Report to the Future Melbourne (Planning) Committee

Agenda item 6.2

Ministerial Planning Referral: ID-2020-3
1 & 3 Southgate Avenue and 16-60 City Road, Southbank

18 May 2021

Figure 20: 2,000m² Publicly Accessible Open Space (Source: application material)

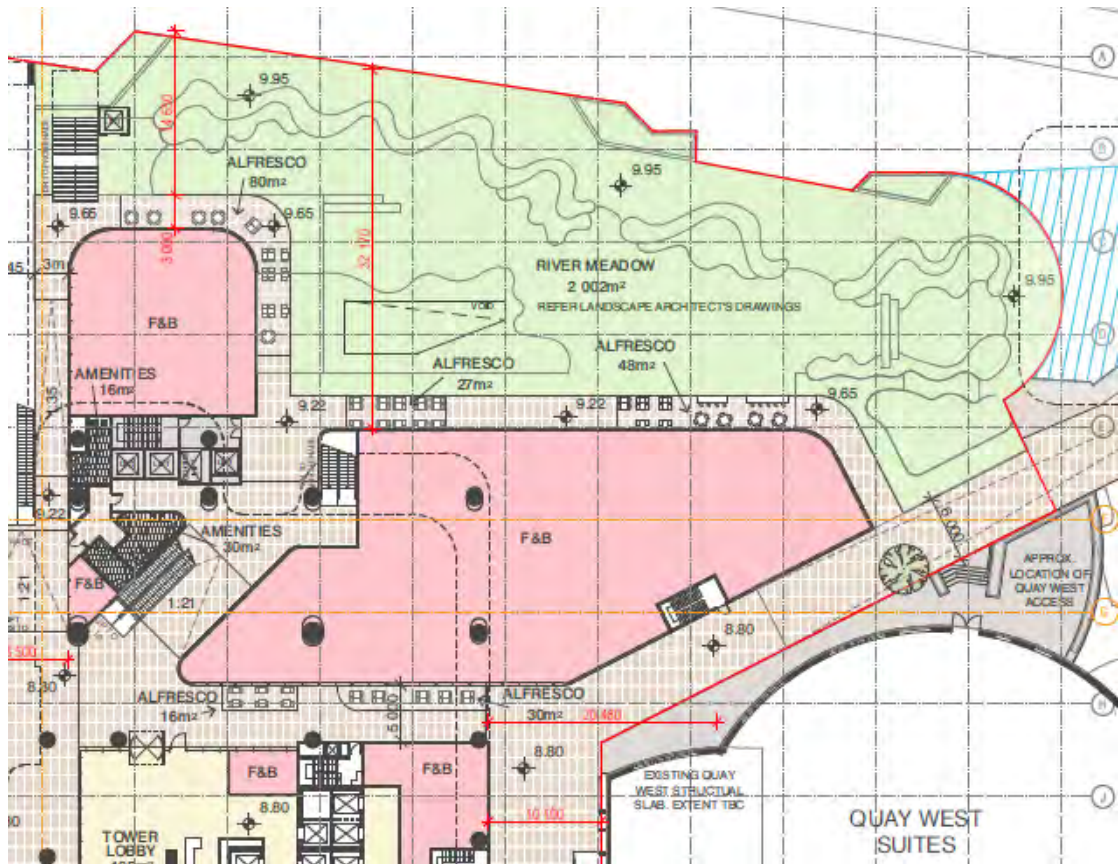
Whether the open space will remain useable and functional as open space with sea level rise and larger storm events.	The public open space will remain useable and functional as open space with sea level rise and larger storm events given its elevation above ground level.
The impact of adjoining land uses.	The adjoining land uses will complement the new public open space and vice versa.
Whether the land or adjoining land is contaminated.	The site and adjoining land is not known to have been used for industry, mining or the storage of chemicals, wastes, gas or liquid fuel.
The location of the site and open space having regard to biodiversity, habitat corridors and the wider open space network.	The public open space will strengthen the biodiversity, habitat corridors and wider open space network along the Yarra River that features tree canopy.
Whether the open space is restricted by services or easements, including roadways, overhead structures, water and power supply, flood mitigation and drainage infrastructure.	The public open space will be unencumbered above, but will remain in private ownership which will avoid encumbrances below.

Whether the open space contributes to the character and attractiveness of the neighbourhood.	The function and design of the public open space will be subject to a project brief developed by Council to ensure that it contributes to the character and attractiveness of the area, including the renewal of Southbank Promenade.
Whether the open space is visually prominent to maximise its use.	The location and dimensions of the public open space ensures that it is visually prominent to maximise its use i.e. on the north side of the site and extending across the entire site frontage, and visible from afar.
Whether the open space is capable of being transferred to Council and rezoned for public open space.	N/A
Whether the open space is able to be improved, maintained and managed by Council.	N/A
